APPLICATION NO.	FILING DATE	FIRST NAMED INVENTOR	ATTORNEY DOCKET NO.	CONFIRMATION NO.
10/729,521	12/05/2003	Richard Floyd Percy	16638-US	2404
30689	7590	03/17/2006	EXAMINER	
DEERE & COMPANY ONE JOHN DEERE PLACE MOLINE, IL 61265			KOVACS, ARPAD F	
			ART UNIT	PAPER NUMBER
			3671

Office Action Summary

DETAILED ACTION

Lip with reinforcing molded metal rod/bar J, thus having the same dimensions

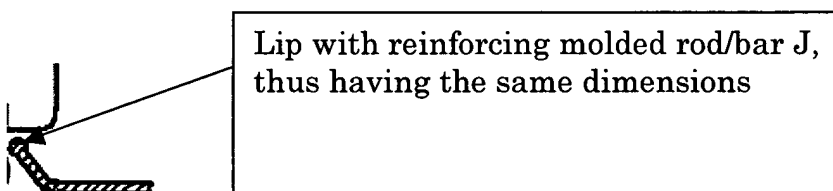
Partsch discloses a box like catcher for a mower, the catcher comprising side panels, a rear facing opening that is facing a rear wall which is considered a top wall with respect to the lower wall (E), at the opening at least one retaining structure molded into the lower wall (as shown below), a primary retaining for a reinforcing metal rod extending across the lower panel (ref J; col. 3, ln 31-32).

rod is cylindrical (see fig. above);

the retaining structure is a channel, passage & is offset (from the side panel) (see fig above);

Partsch discloses a box like catcher, comprising side panels, a rear facing opening & lower panel with an elevated lip (see lip below) at the opening at least one retaining structure (see molded lip & retaining portion below), that is offset (from the sides) and which is providing a primary retaining for a reinforcing metal rod (ref J; col. 3, ln 31-32). The rod extending through an access hole of the side panels (that includes the sides of the lip) & above at least some portions of the lower wall (see fig below). The rod may be press fitted or molded as shown. The grass catcher capable of being used with a reel type mower (col. 3, ln 8). Although, it is not shown it is conceivable that some of the reinforcing rod is exposed facing upwardly, especially when the grass catcher is placed side ways & the ends face upwardly & exposed.
